Origination Form
Proposed Revisions to a Standard Plans Index

Originator:	Stepp, Richard	Index Number:	715-003
Date:	6/30/2026	Sheet Number(s):	1, 3, 4
E-mail:	richard.stepp@dot.state.fl.us	Index Title:	Utility Conflict Pole

SPREAD FOOTING FOUNDATION OPTION

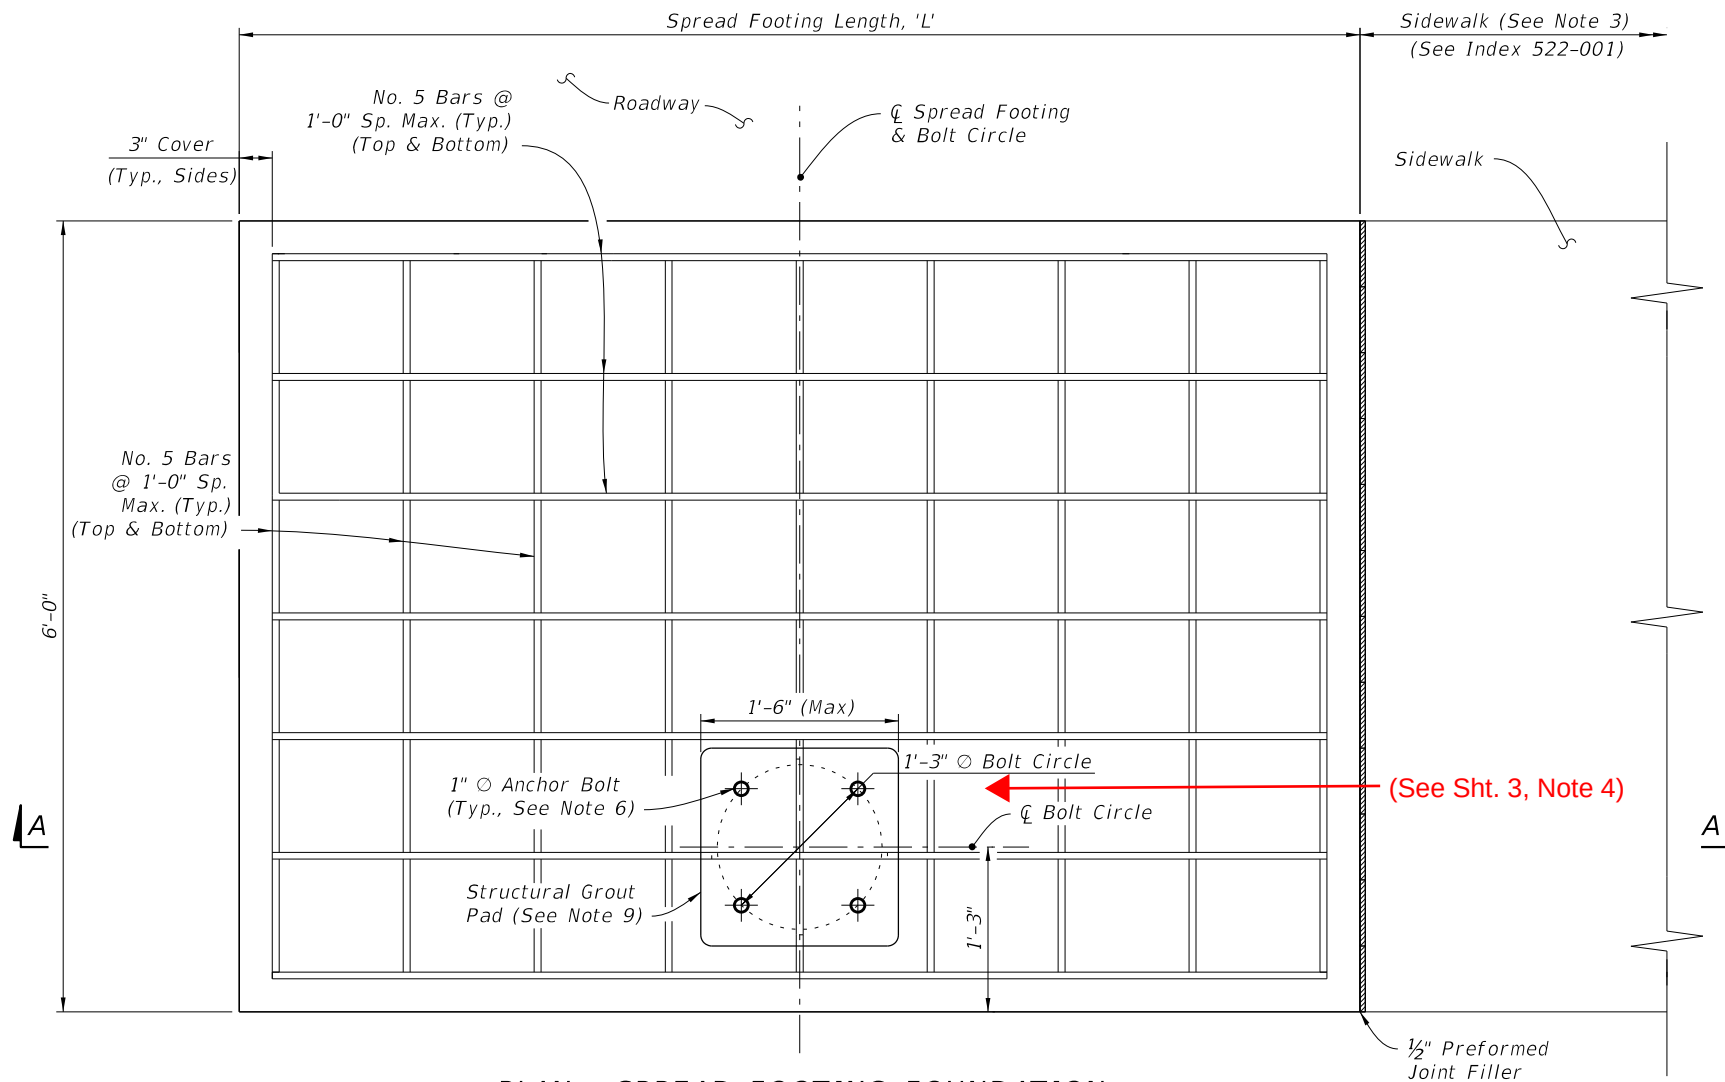
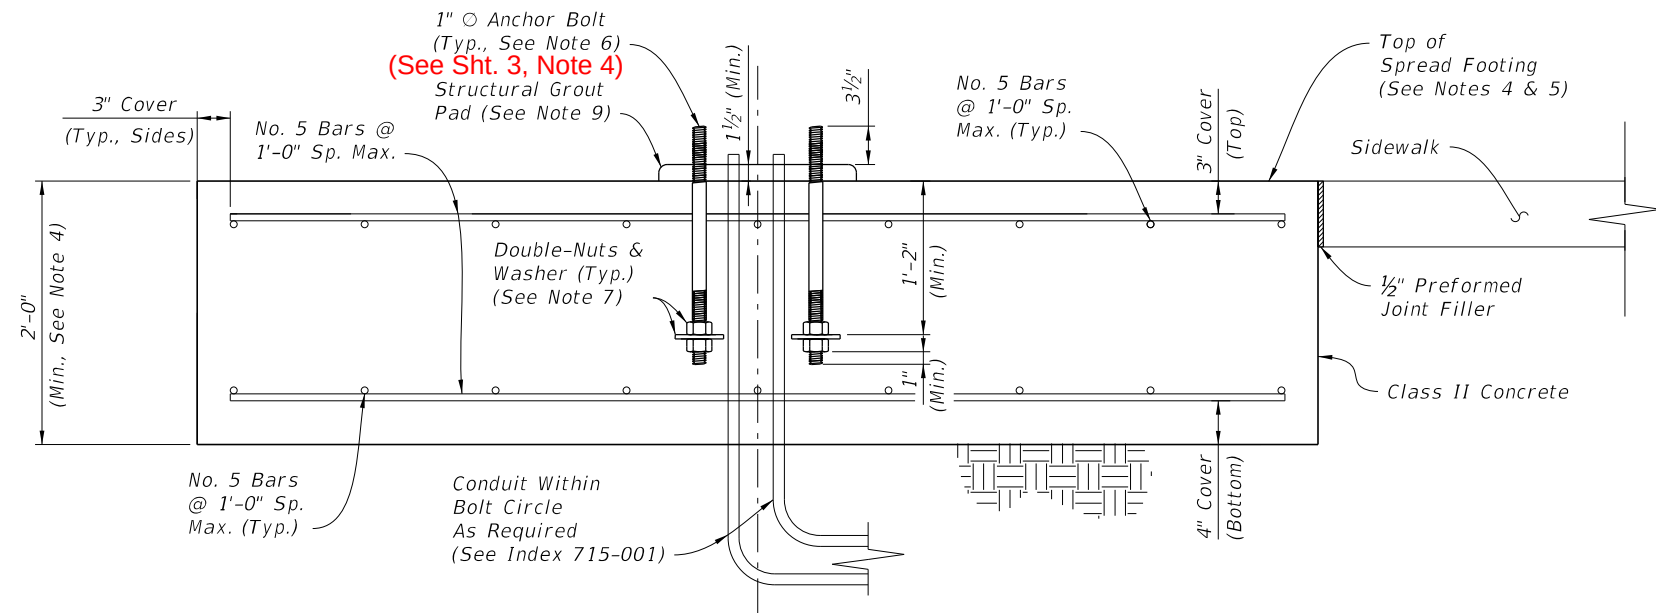
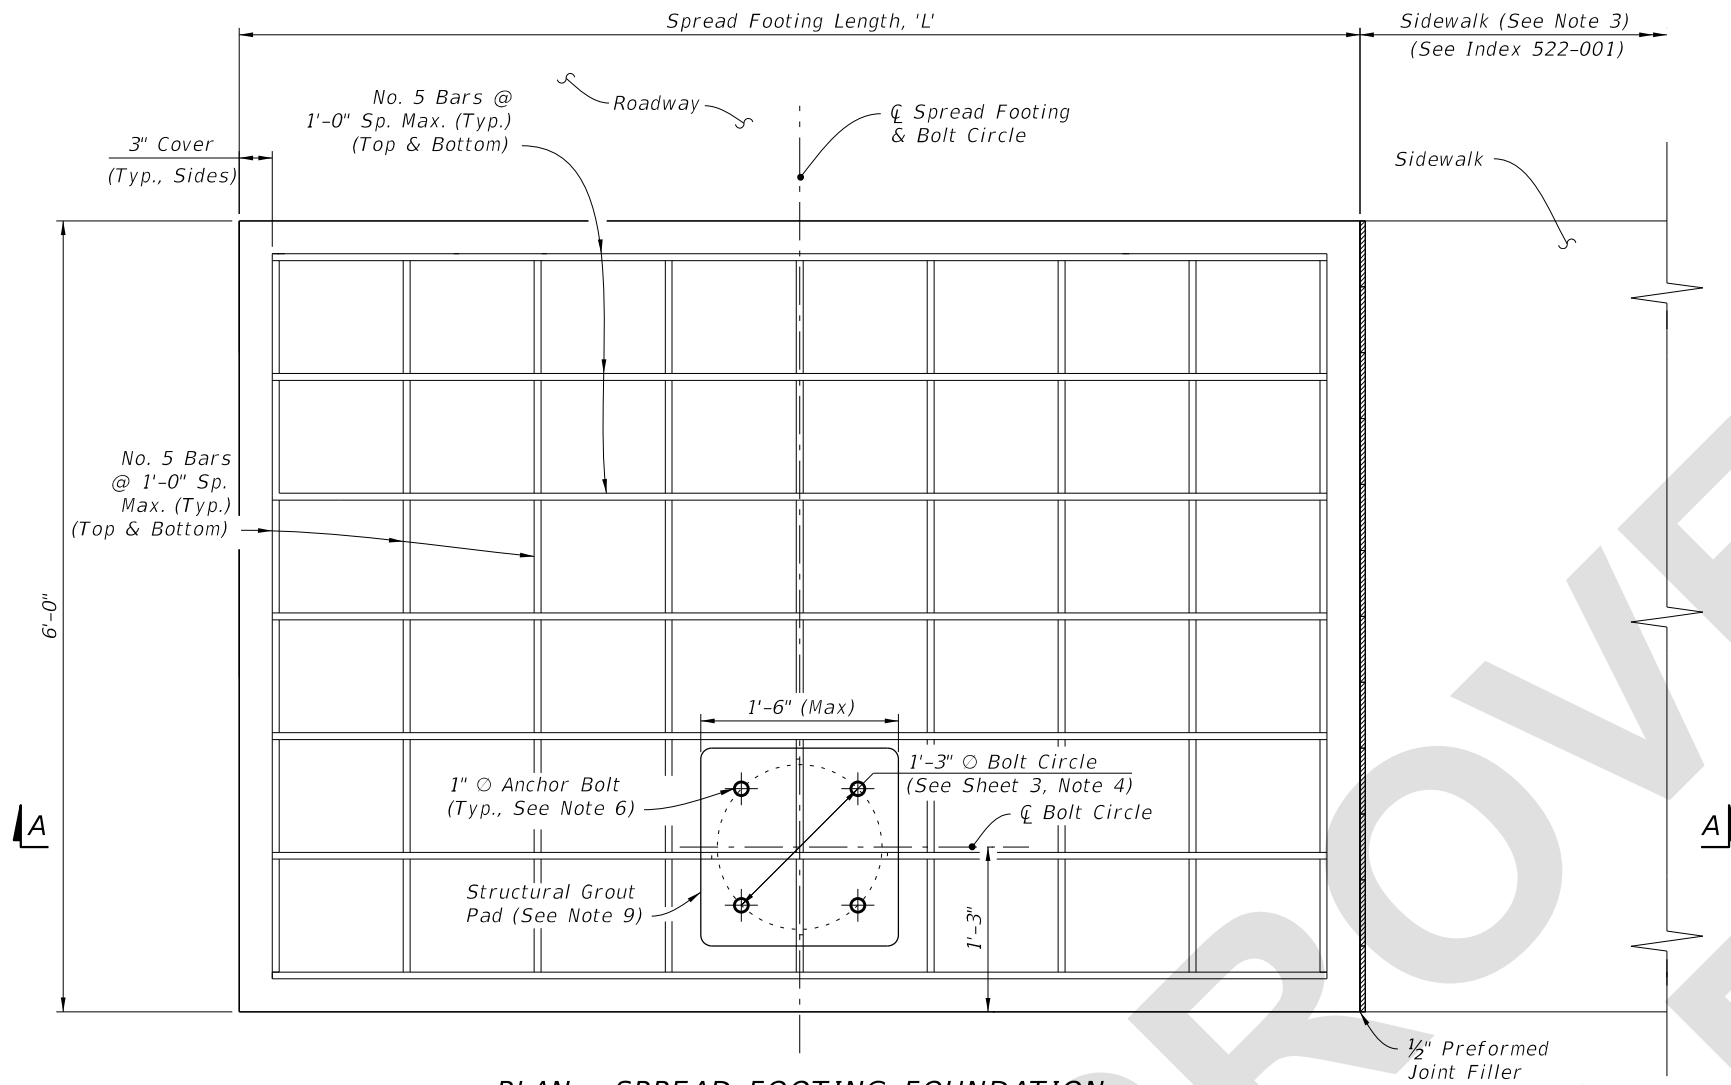
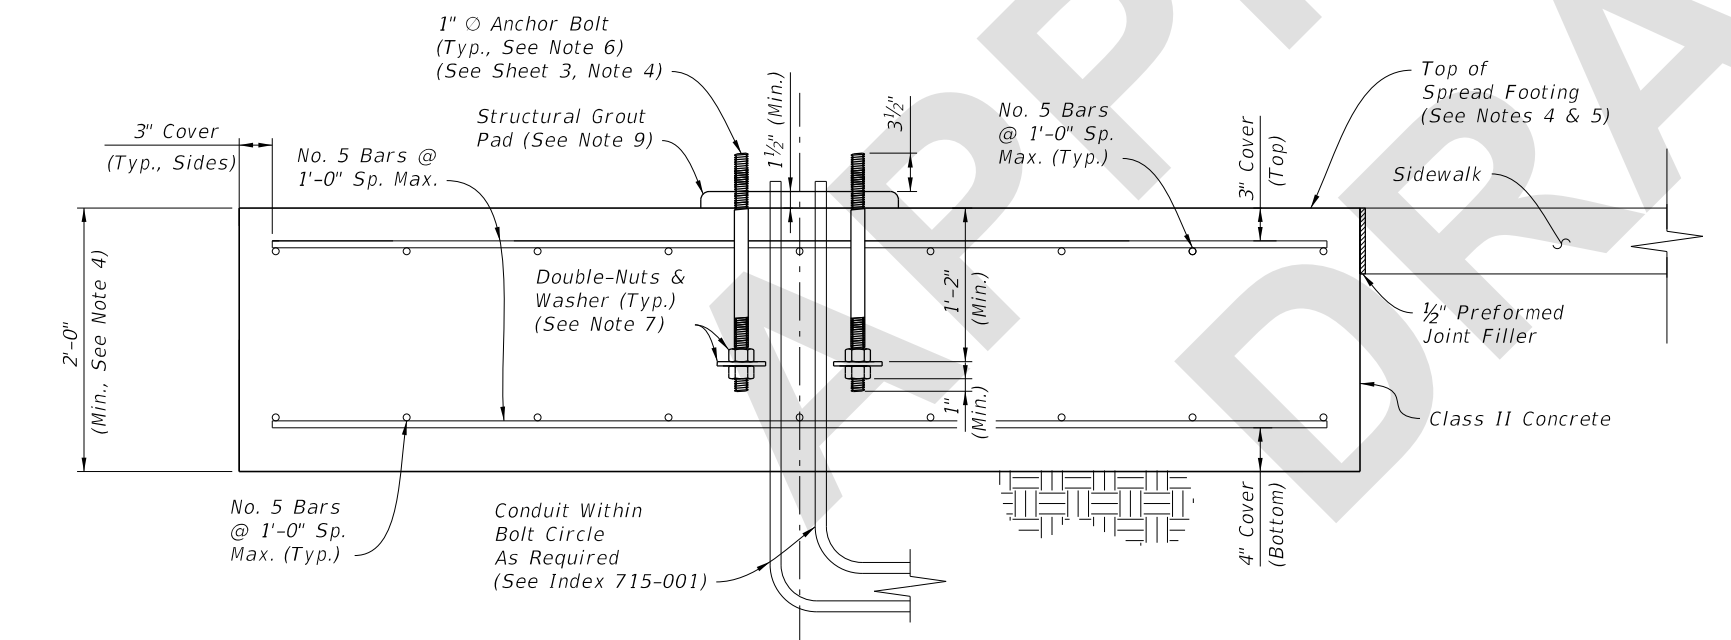
Sheet 1: Updated General Note 2 with new information about shop drawing requirements for frangible bases on the APL; Revised General Note 3 so that a material requirement applies to "Transformer Base" and not all "Frangible Base" options; Revised General Note 6 to address all frangible base options on the APL; Updated the Frangible Base callout in the "Light Pole Base Elevation" to include all other options besides Transformer Base. Sheet 3: Added Note 4 to address requirements for Frangible Base options on the APL; Added Note 4 references in the drawings.
Sheet 4: Added references to Note 4 on Sheet 3 for additional information regarding APL options.
